Docket Number:	12-AFC-03
Project Title:	Redondo Beach Energy Project
TN #:	201547
Document Title:	Data Response Set 1B 50 and 51
Description:	N/A
Filer:	Sarah Madams
Organization:	CH2M HILL
Submitter Role:	Applicant Consultant
Submission Date:	1/13/2014 12:22:49 PM
Docketed Date:	1/13/2014

Subject: Redondo Beach Energy Project (12-AFC-03)
Data Response Set 1B – Responses to CEC Staff Data Requests 50 and 51

Data Responses, Set 1B (Responses to Data Requests 50-51)

FIGURE DR50A-1
 Conceptual Wet Tower Placement
 AES Redondo Beach Energy Project
 Redondo Beach, California

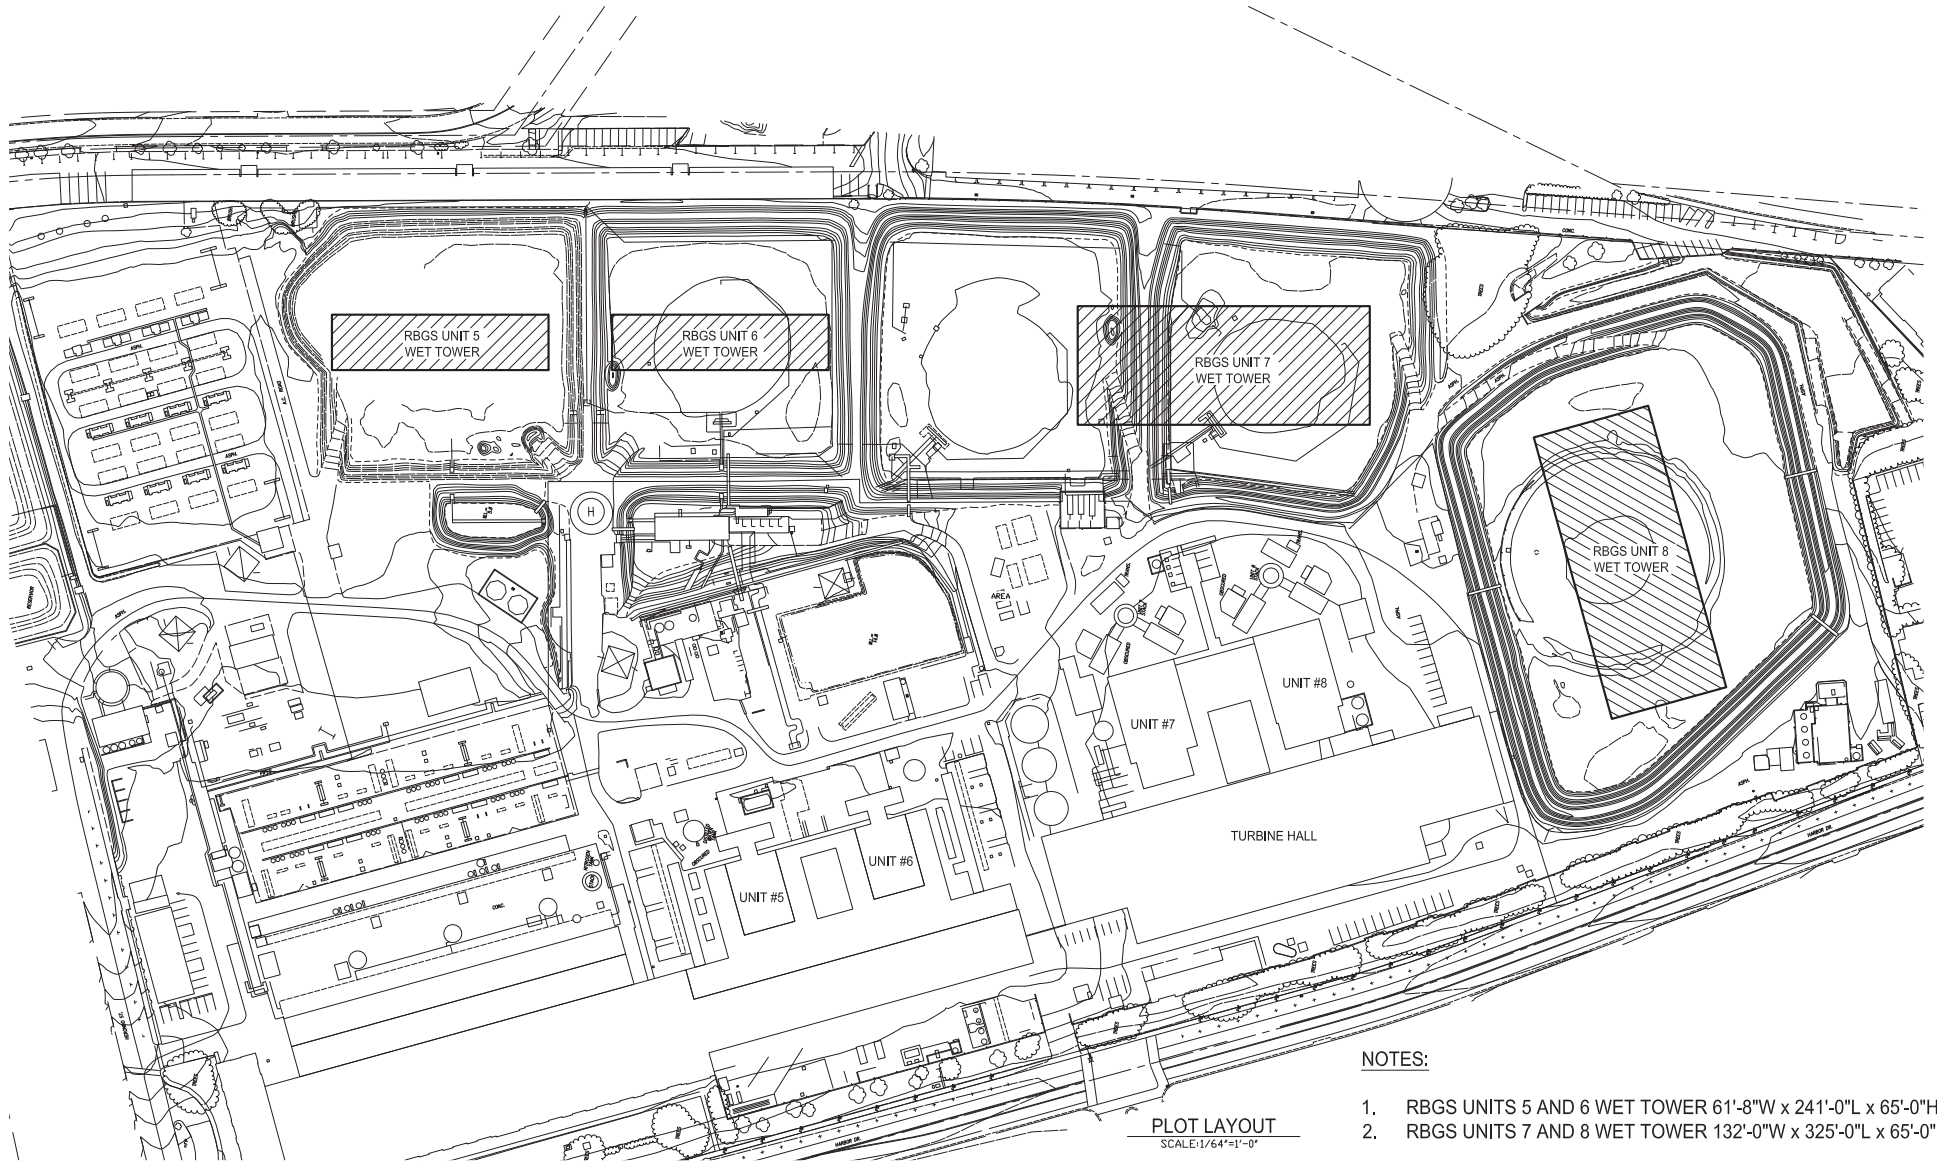
- a. For a closed-loop cooling system, please provide a location and height of the necessary cooling towers (wet cooling system) and/or air-cooled condenser (dry cooling system). Please describe all necessary improvements and infrastructure needed for retrofitting the RBGS to a closed-loop system, as well as cooling design parameters (such as heat rejection capacity, number of cells, and water recirculation rate).

The cooling equipment for wet- or dry-cooling could be located in any vacant area onsite with adequate space. A potential location is along the east/south edges of the site as shown in Figures DR50A-1 and -2. The size of the cooling towers is provided in the lower right-hand corner of the drawings.

1. RBGS UNITS 5 AND 6 WET TOWER 61'-8"W x 241'-0"L x 65'-0"H
2. RBGS UNITS 7 AND 8 WET TOWER 132'-0"W x 325'-0"L x 65'-0"H

FIGURE DR50A-2
 Conceptual Dry Tower Placement
 AES Redondo Beach Energy Project
 Redondo Beach, California

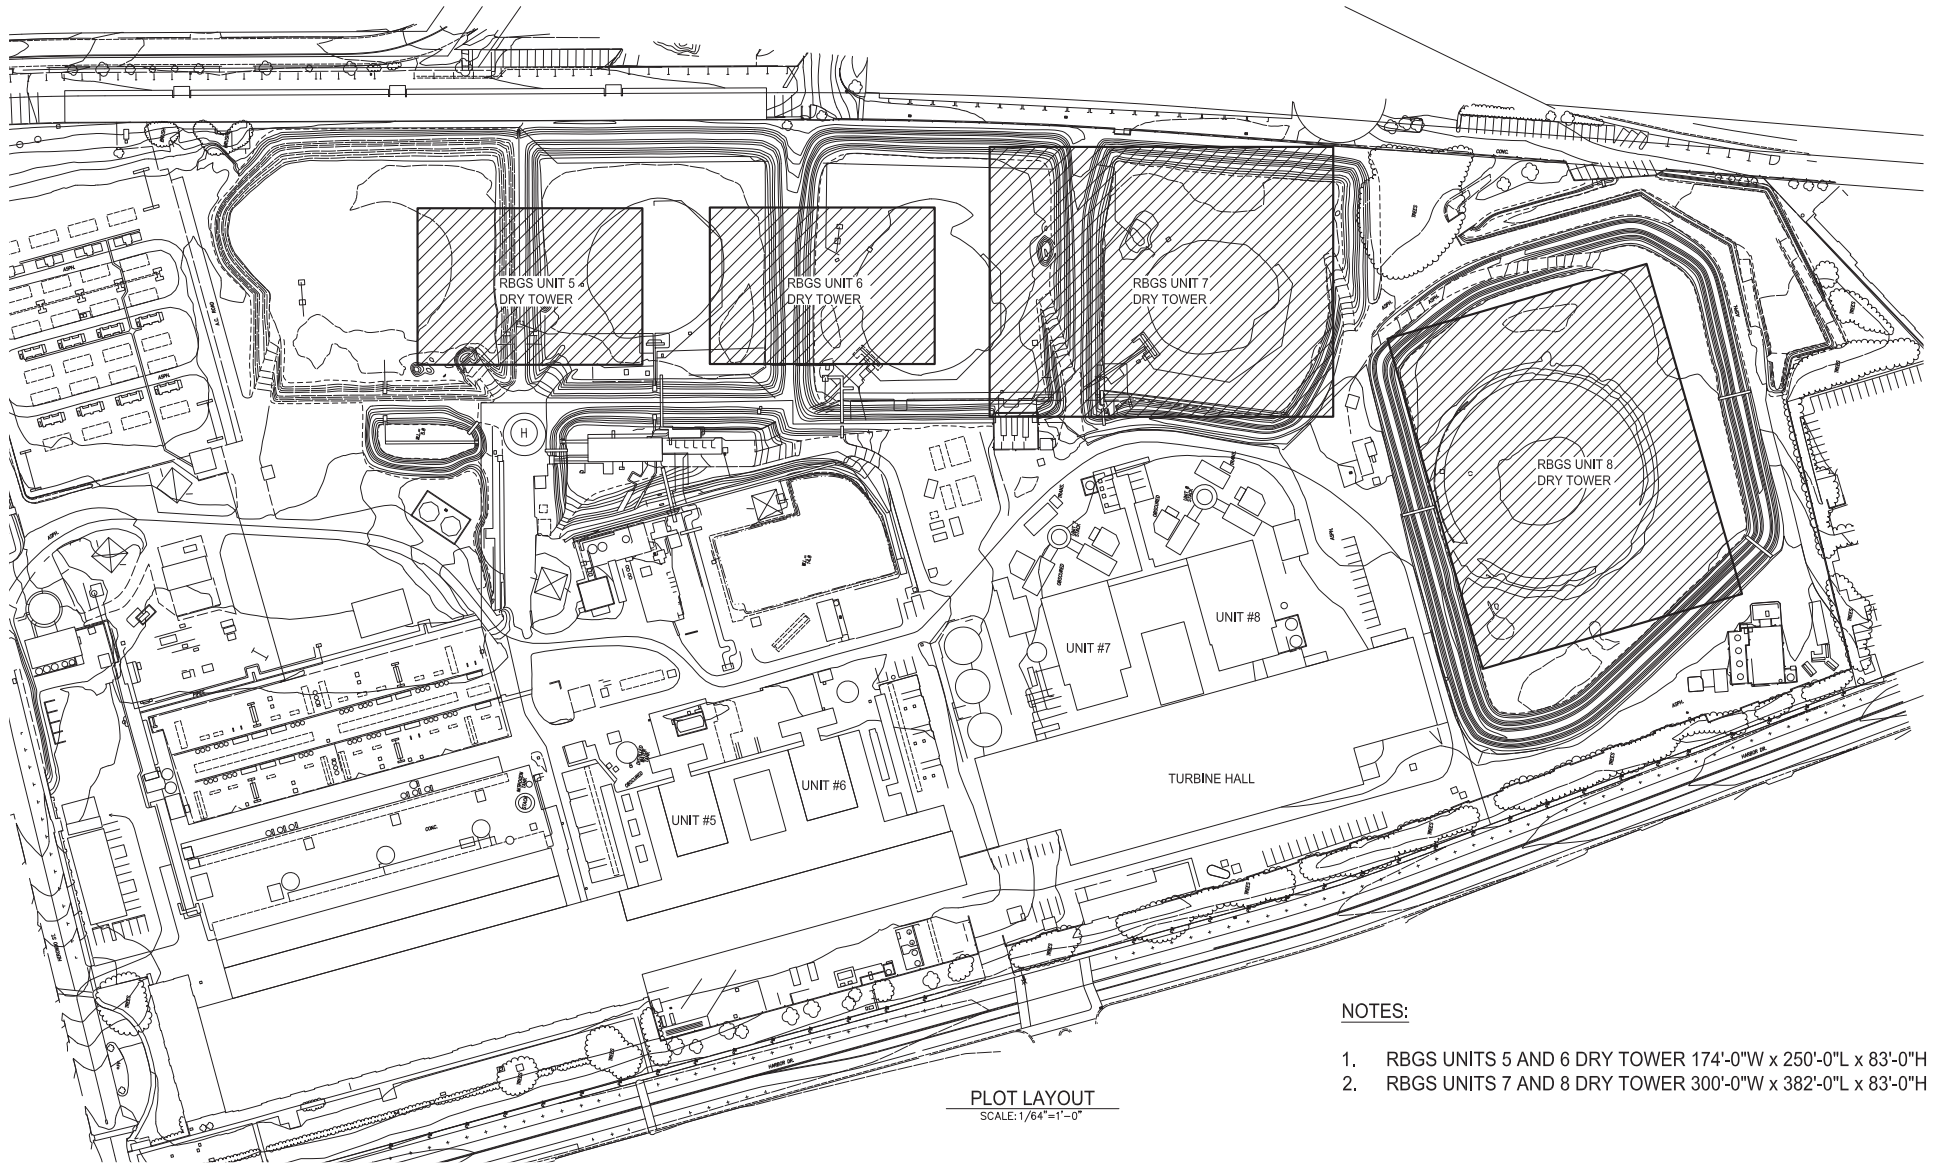
- d. Please describe all necessary improvements and infrastructure needed for retrofitting the RBGS to utilize an air-cooled condenser, describing changes to on-site component height and massing. Provide details (including a site map, layout, etc.) and substantiate any RBGS site size constraints for this retrofit scenario.

1. RBGS UNITS 5 AND 6 DRY TOWER 174'-0"W x 250'-0"L x 83'-0"H
2. RBGS UNITS 7 AND 8 DRY TOWER 300'-0"W x 382'-0"L x 83'-0"H

FIGURE DR50B-1
Reclaimed Water Sources
 AES Redondo Beach Energy Project
 Redondo Beach, California

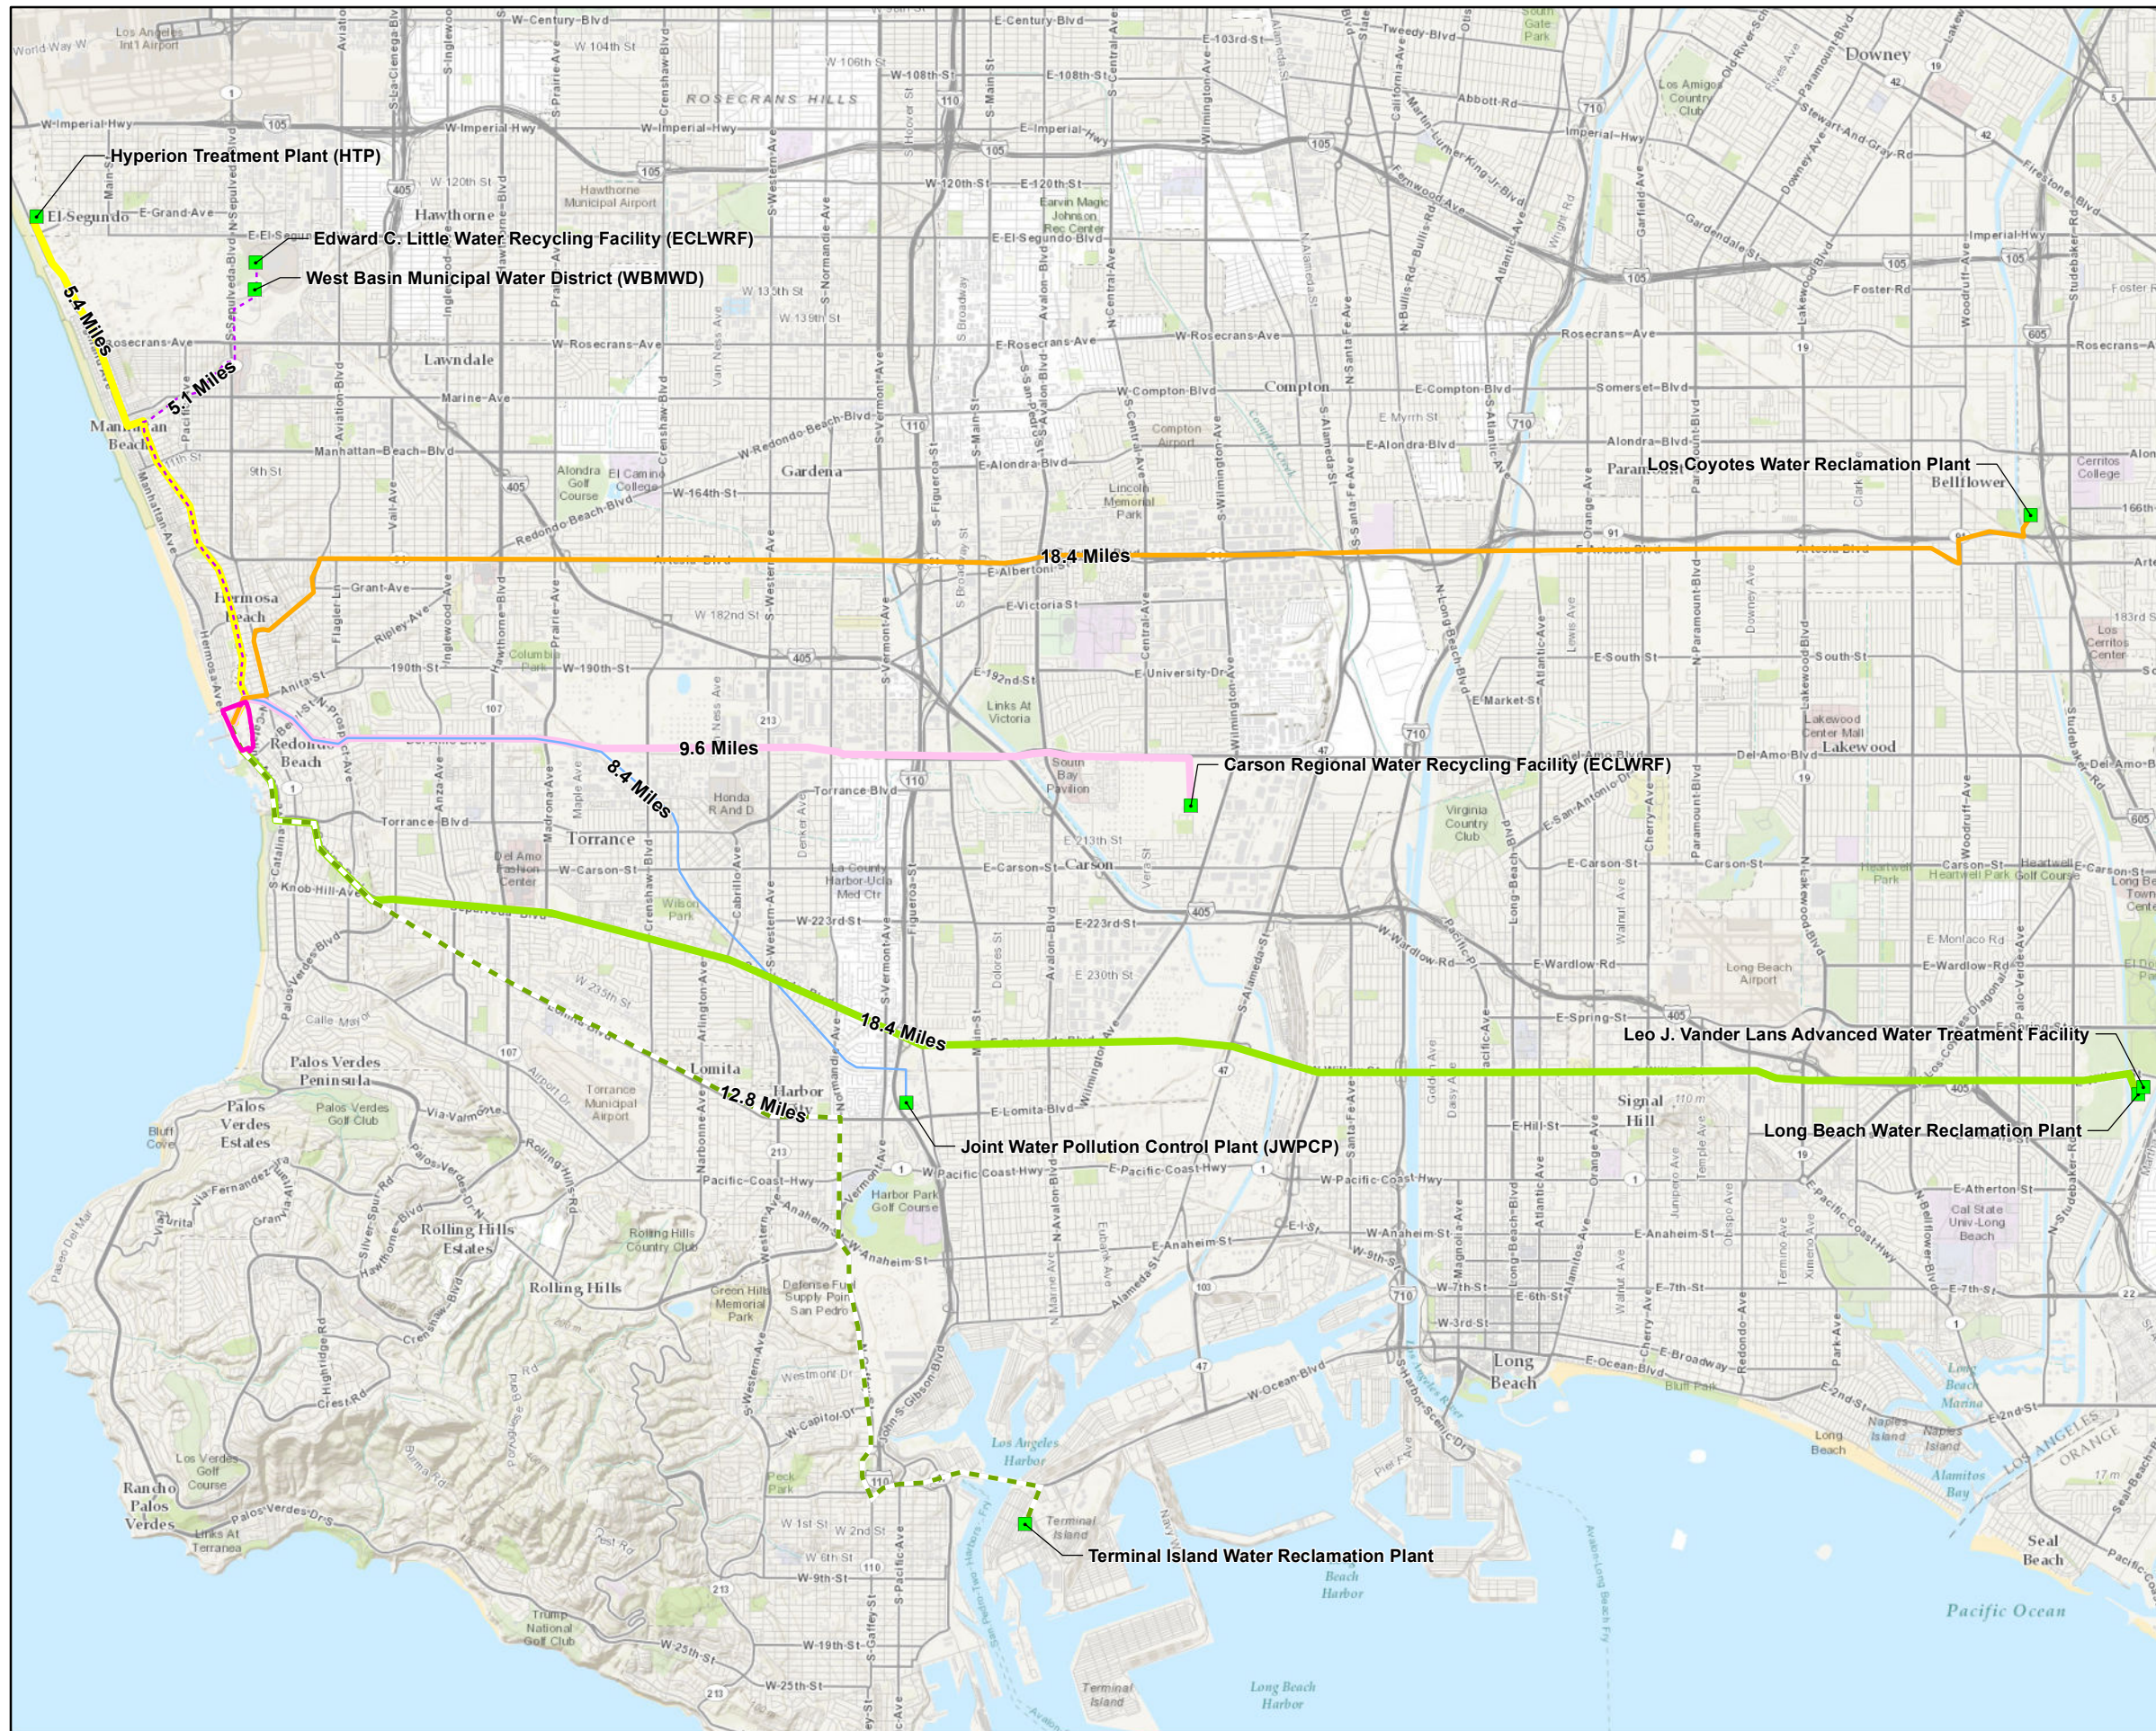
- b. AFC Section 6.4 states that Title 22 Reclaimed water is limited in the South Bay area. Provide in detail and substantiate why reclaimed water in the South Bay area is not available in sufficient quantities to serve the RBGS under a wet- or dry-cooled retrofit utilizing such a water source. Please provide details regarding the nearest available reclaimed water source able to adequately support a wet-or dry-cooled retrofit for the long-term and discuss what necessary infrastructure (pipeline, pipeline route, treatment facility, etc.) would be needed to provide reclaimed water to the site in quantities sufficient to serve either a wet- or dry-cooled retrofit scenario utilizing a reclaimed water source. Also, provide an estimate as to the daily amount of non-potable water used under these retrofit scenarios.

These and other possible facilities are addressed below and summarized in Table DR50B-1. Pipeline routes shown in Figure DR50B-1 are illustrative only and do not include consideration for right-of-way availability, engineering or other considerations.
